TECHNICAL INFORMATION JDE

Type Coffee Vending Machine	Model 9100	T.I. NO 01 - 2017	
Serial Number 71011428	Subject ADAPTER FOR TEFLON HOSE - NOZZLE	ISSUED FOR (X)	Action Information X

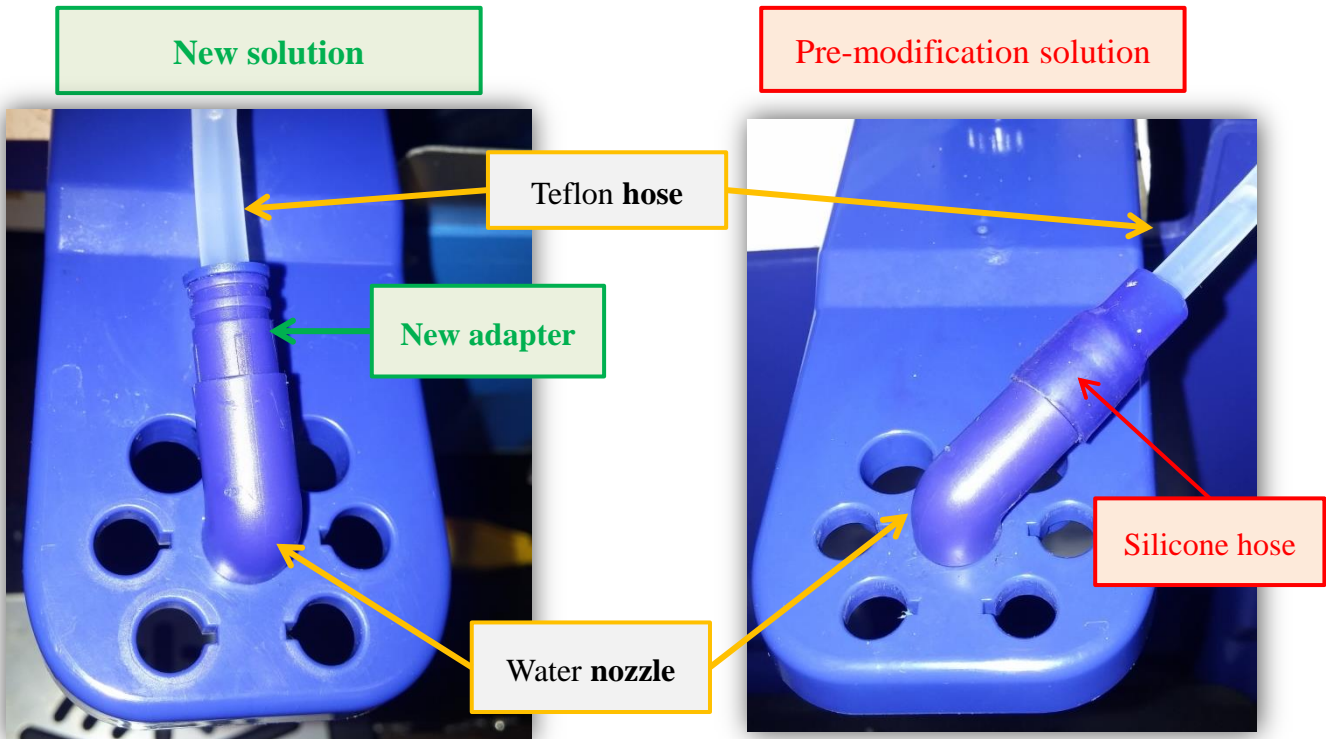
The adapter goal it's to facilitate the teflon-hose fit with the water-nozzle.

The **new adapter** replaces the silicone hose and allows to fit easily the *teflon-hose* with the *water-nozzle*.

New adapter Spare code:
261103 SAP:55117442

Machines concerned by modification from S/N 71011428.

For machines previous to S/N above it's possible to mount the **new adppter**.
